# Access Compliance Report

## Public Rights-of-Way

### (Curb Ramps)

Intersection ID: 44702	Main Street: PATRIOTS_POINT_LN	Cross Street: EAGLES_LANDING_DR	Location: NE
ADA ID: 6AC7B346AA2C	Ramp Type: Perp	Initial Pass/Fail: Fail	Overall Compliance: No
Severity Score: 8.75			
Codes/Mitigation Info/Possible Solution		Field Measurements/Component Compliance

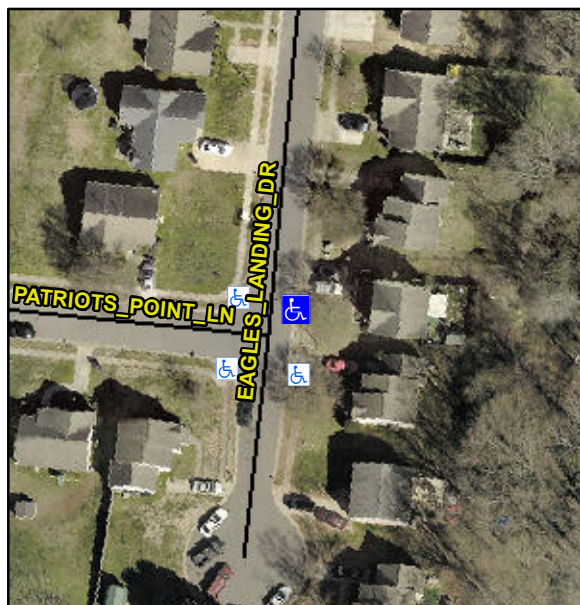
**Not Found, R304.5.1**

Compliance	Description	Data	Compliance	Description	Data
N/A	Ramp Length (in)	47.0	Yes	Ramp Slope (%)	5.1
No	Ramp Width (in)	44.0	Yes	Ramp XSlope (%)	0.3
N/A	Flare Type LT	N/A	N/A	Flare Type RT	N/A
N/A	Flare Slope LT (%)	N/A	N/A	Flare Slope RT (%)	N/A
N/A	Flare Traversable LT?	N/A	N/A	Flare Traversable RT?	N/A
N/A	Landing Length (in)	N/A	N/A	DWS Provided?	N/A
N/A	Landing Width (in)	N/A	N/A	DWS Contrast?	N/A
N/A	Landing Slope (%)	N/A	N/A	DWS Length (in)	N/A
N/A	Landing X Slope (%)	N/A	N/A	DWS Full Width?	N/A
N/A	Landing Curb? (Y/N)	N/A	N/A	DWS Offset (in)	N/A
N/A	Shared Landing?	N/A			
N/A	Gutter Ponding?	N/A	N/A	Gutter Slope (%)	N/A
N/A	Gutter Lip Ht (in)	N/A	N/A	Gutter X Slope (%)	N/A
N/A	Painted X Walk1?	No	N/A	Painted X Walk2?	N/A
	X Walk 1 Direction	To W		X Walk 2 Direction	N/A
N/A	X Walk 1 Width (in)	N/A	N/A	X Walk 2 Width (in)	N/A
	X Walk 1 Slope (%)	3.2		X Walk 2 Slope (%)	N/A
	X Walk 1 X Slope (%)	0.7		X Walk 2 X Slope (%)	N/A

**Remove & Replace Entire Ramp.**
